Board of Park Commissioners

Agenda

Thursday, August 18, 2022 | 6:30 PM | Council Chambers and Virtual

RE: Nelson Pavilion Conceptual Design Review

FIRST FLOOR PLAN

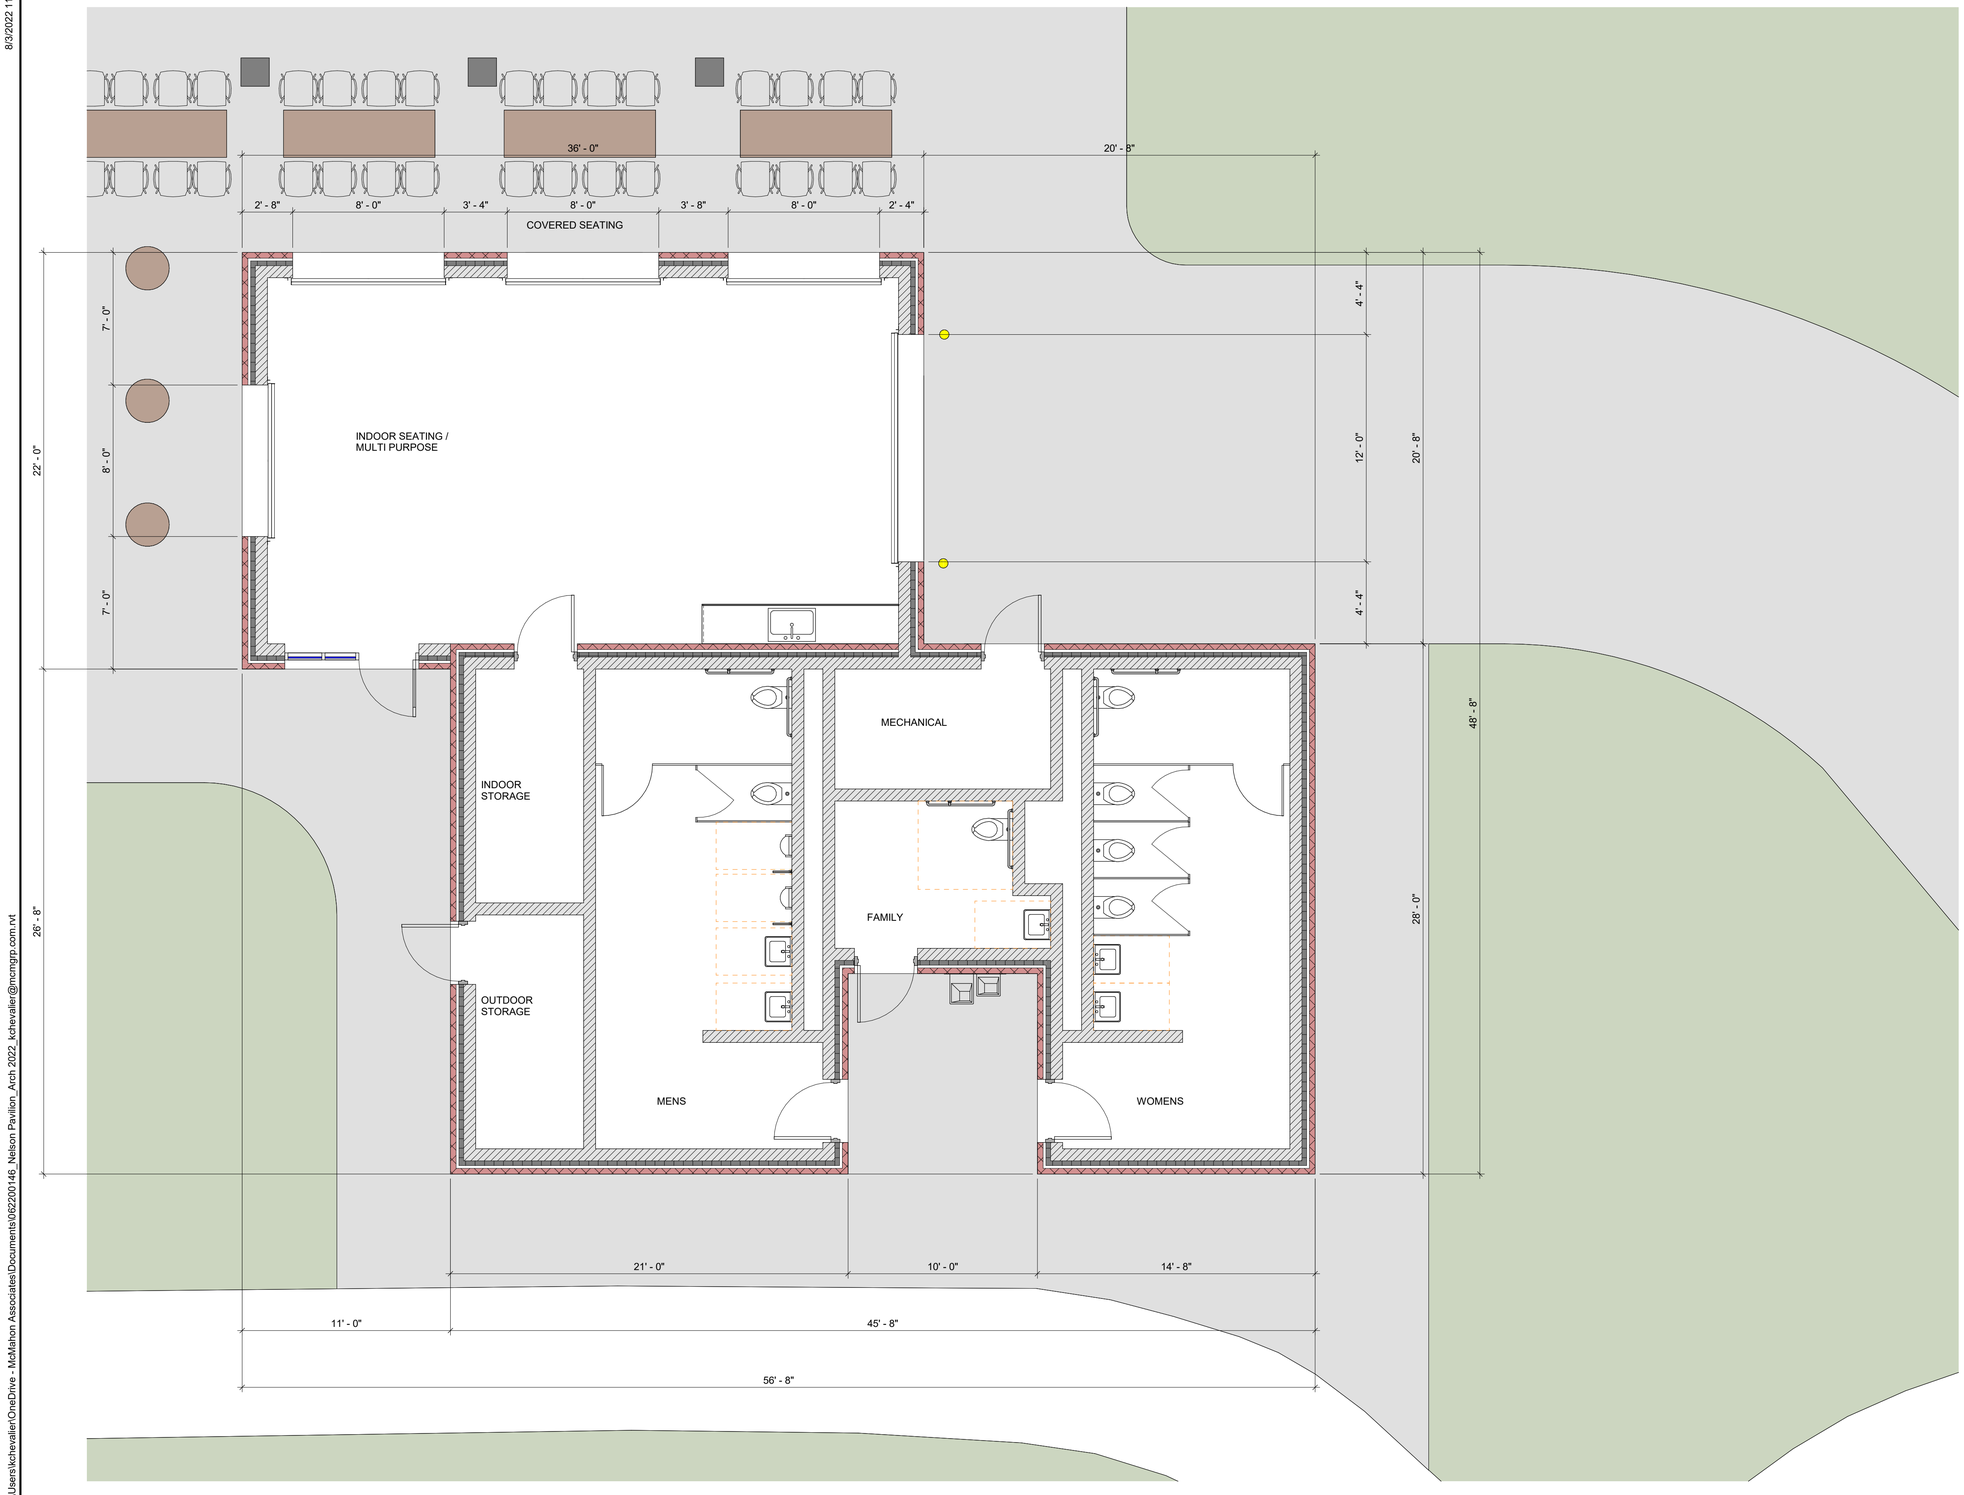
At our meeting last month the Park Board asked our consultant to review and consider changes to the restroom area. Based on those recommendation our consultant did go back and make alterations and a proposed new layout to the Nelson Family Pavilion. Included in your packet is a rendering of the original design, a rendering of the new concept proposed based on the Park Board comments last month, and a copy of the rendering and questions/notes that was presented to you last month.

New Layout:
While the new layout provides for a greater amount of usable restrooms to everyone, staff have a list of concerns related to the new layout.

- First, we believe the common area will become a challenge for safety and security. It is an enclosed area that can not be viewed from anyone outside. This could become a place for loitering, vandalism, and eventually make restroom users uncomfortable.
- We believe the proposed style will be more challenging and time consuming to clean.
- With the universal restroom style and the elimination of urinals, we think the restrooms will not be as clean and sanitary as people would like.

- Expand the mechanical chases so they can be accessed.
- Review the ability to provide a universal bathroom to the multi-use room.
- Develop location for vending machines and garbage/recycling.

ARCHITECTURAL SITE PLAN
3/16" = 1'-0"

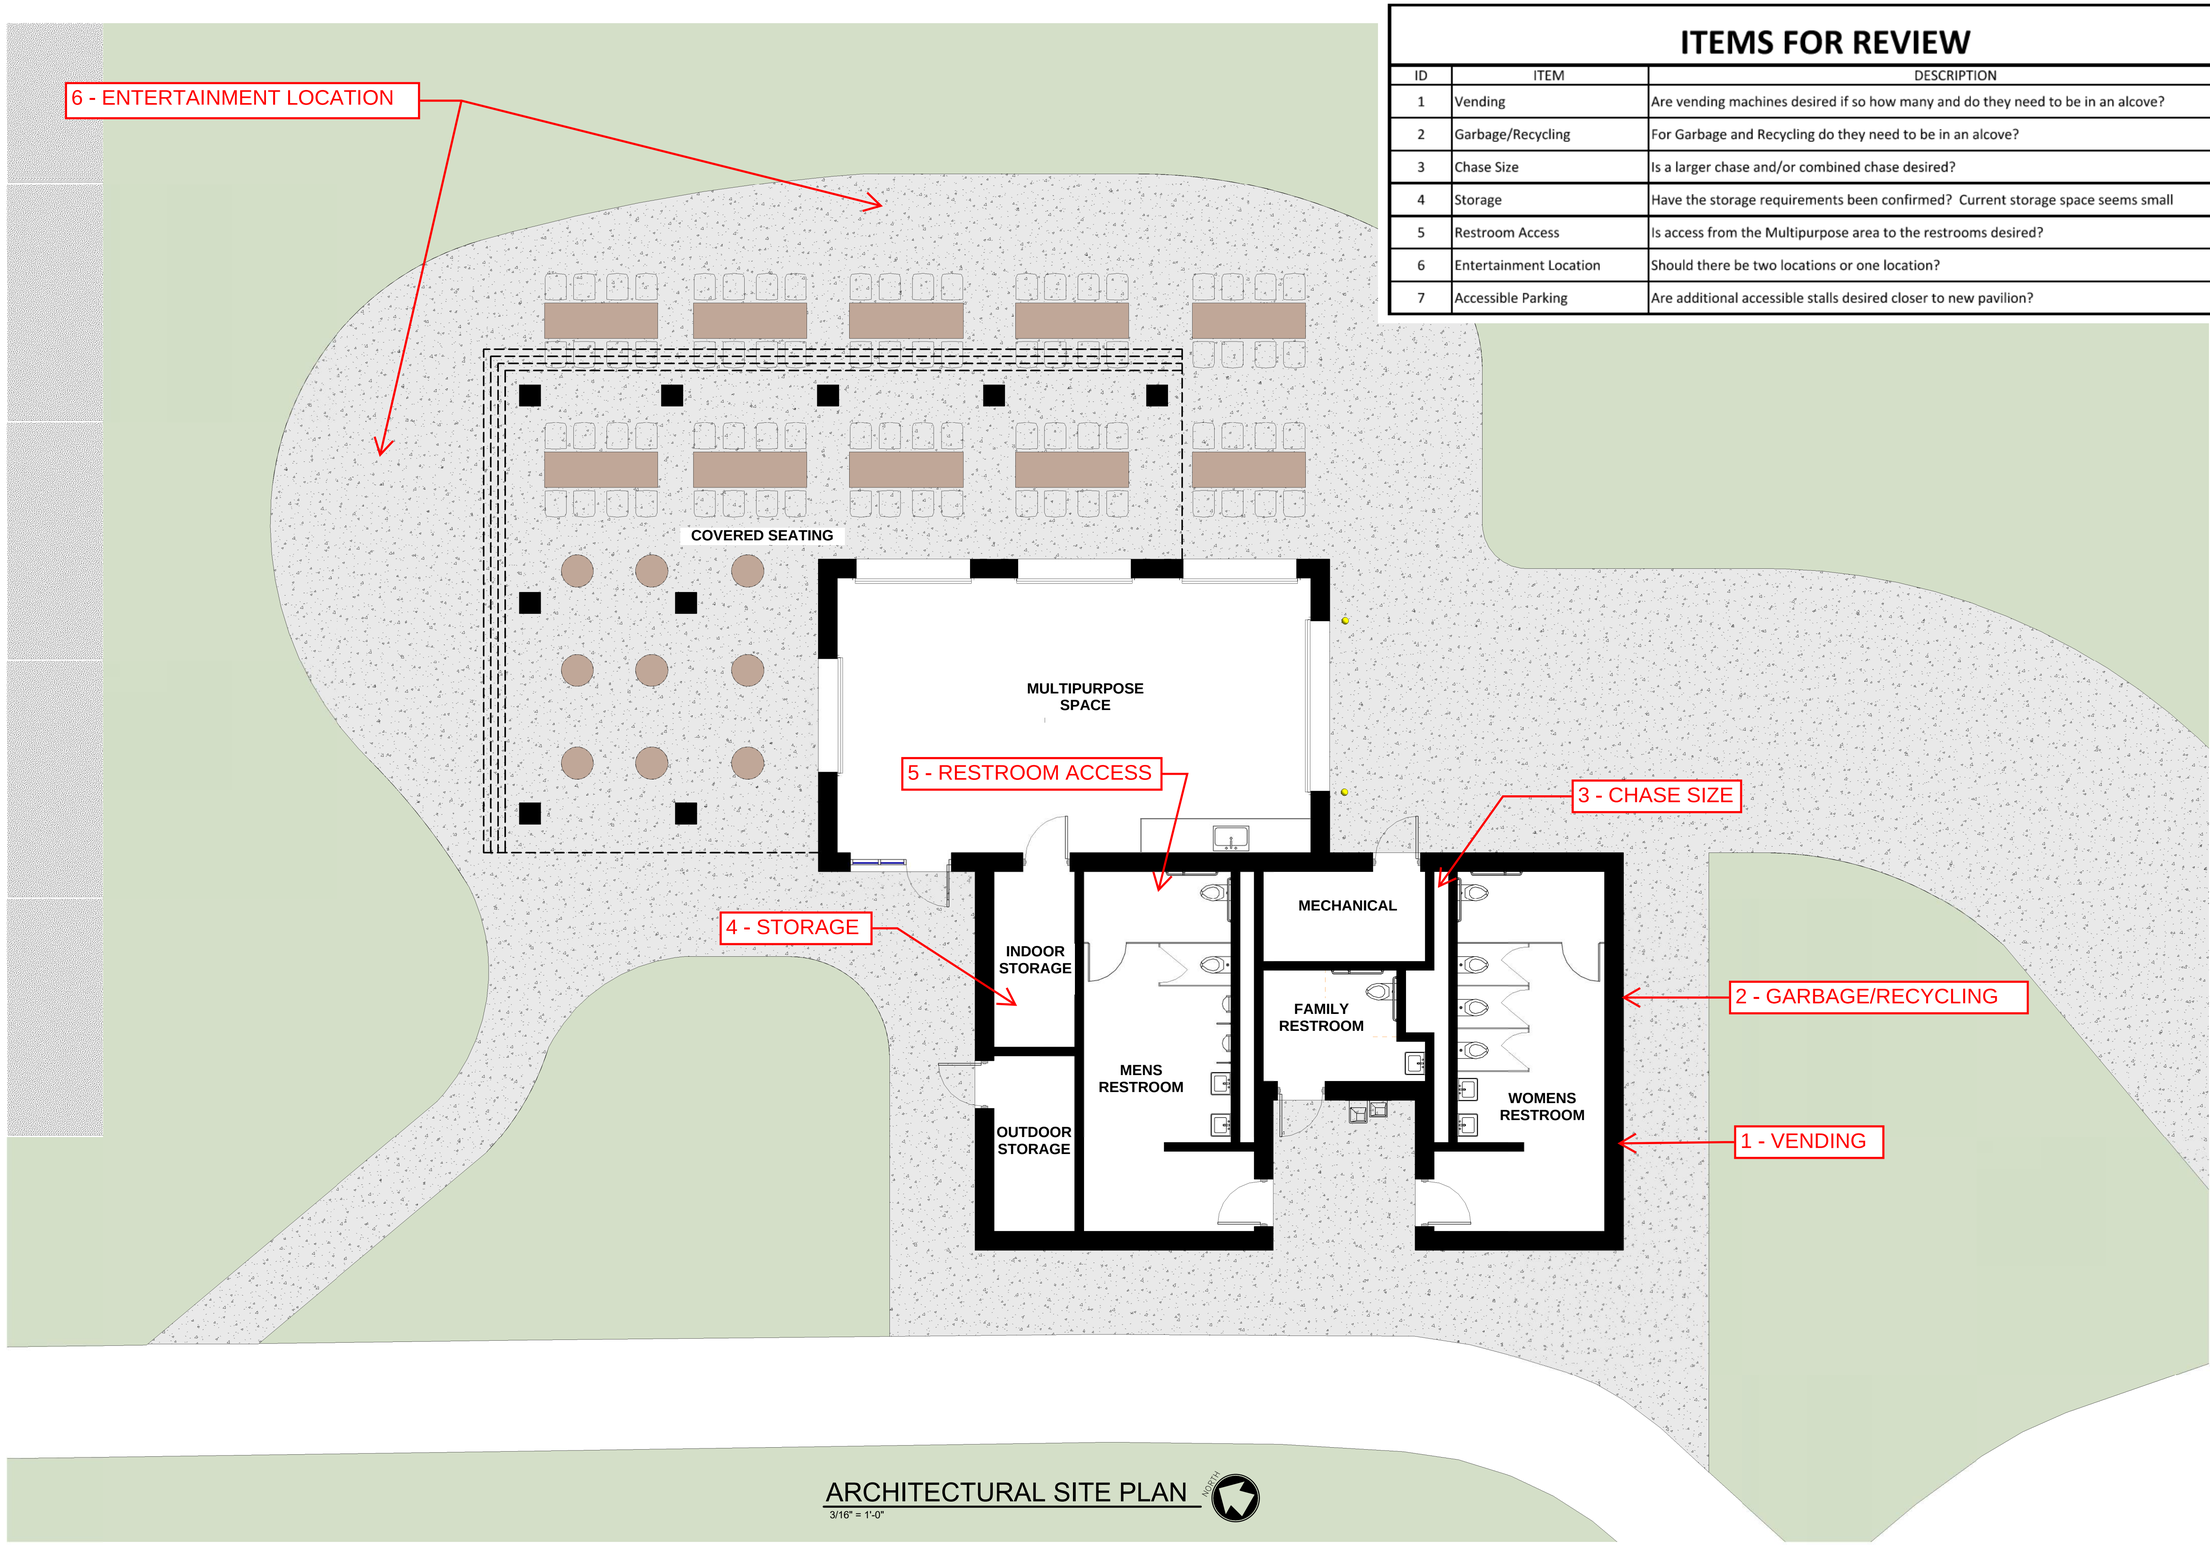
ID	ITEM	DESCRIPTION
1	Vending	Are vending machines desired if so how many and do they need to be in an alcove?
2	Garbage/Recycling	For Garbage and Recycling do they need to be in an alcove?
3	Chase Size	Is a larger chase and/or combined chase desired?
4	Storage	Have the storage requirements been confirmed? Current storage space seems small
5	Restroom Access	Is access from the Multipurpose area to the restrooms desired?
6	Entertainment Location	Should there be two locations or one location?
7	Accessible Parking	Are additional accessible stalls desired closer to new pavilion?
